Technical Review: Impacts of the Proposed Aquarium Revitalization and Expansion on Stanley Park (September 2006)

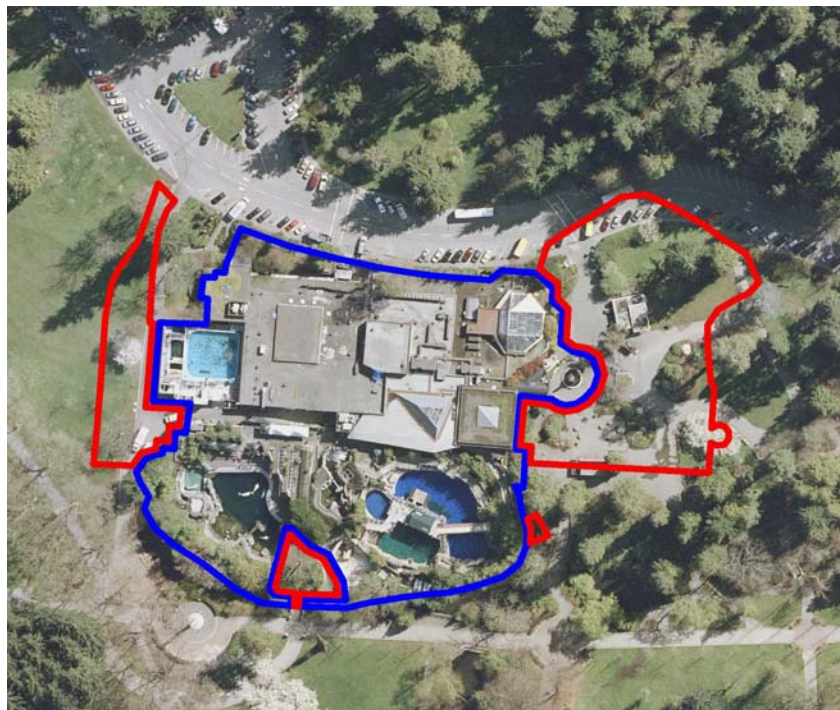
When the Aquarium opened in 1956, it covered about 0.13 hectares (0.33 acres) of land in Stanley Park. The Aquarium was expanded 8 times in the last 50 years. Today, the Aquarium occupies 1.2 hectares (2.9 acres) in Stanley Park (outlined in blue on the map).

The proposal would increase the Aquarium's footprint to 1.8 hectares (4.4 acres), an addition of 0.6 hectares (1.5 acres) or a 50% increase (outlined in red on the map).

The Park Board has been and is very cautious about removing portions of Stanley Park from the public domain (either by fully restricting public access or requiring a fee for entry).

The evaluation depends on the value assigned to the land in question: whether it is believed that Stanley Park is better served by having the land kept as publicly-accessible open space, or by having the land incorporated as part of a successful educational and tourist institution.
